UNITED STATES PATENT AND TRADEMARK OFFICE

APPLICATION NO.	FILING DATE	FIRST NAMED INVENTOR	ATTORNEY DOCKET NO.	CONFIRMATION NO.
09/531,735	03/21/2000	Shalom Levin	EPLC/03	7129
30954	7590	06/02/2006	EXAMINER	
LATHROP & GAGE LC 2345 GRAND AVENUE SUITE 2800 KANSAS CITY, MO 64108			KOVACS, ARPAD F	
			ART UNIT	PAPER NUMBER
			3671

Office Action Summary

DETAILED ACTION

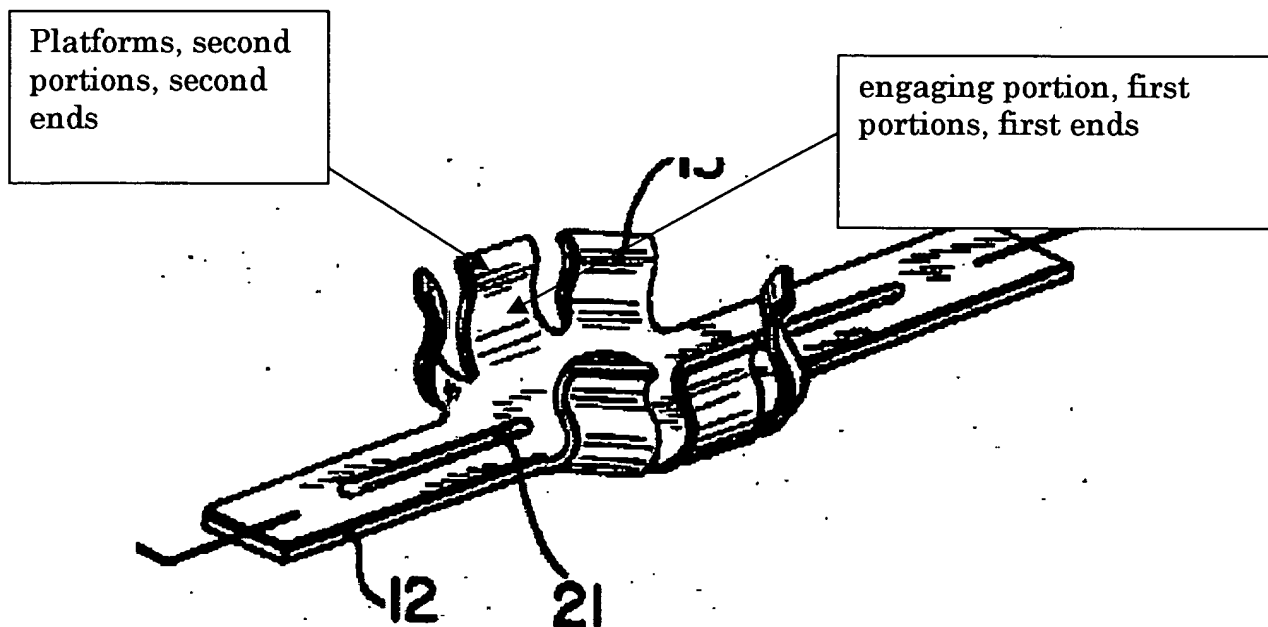
4. Claim(s) 9-22 are rejected under 35 U.S.C. 102(b) as being anticipated by Weber (3670413).

As shown in the marked up figures below, Weber discloses:

a shaft (15);

a stub (hub 14: groove 19 & cylindrical portion 20) in communication with shaft (fig 2);

a blade (12);

a receiver coupled to the blade (fig 2) including:

a receiving portion (central web 22);

flexible members (spring clips 13) including:

engaging portions and platforms disposed at opposite ends (see fig above);
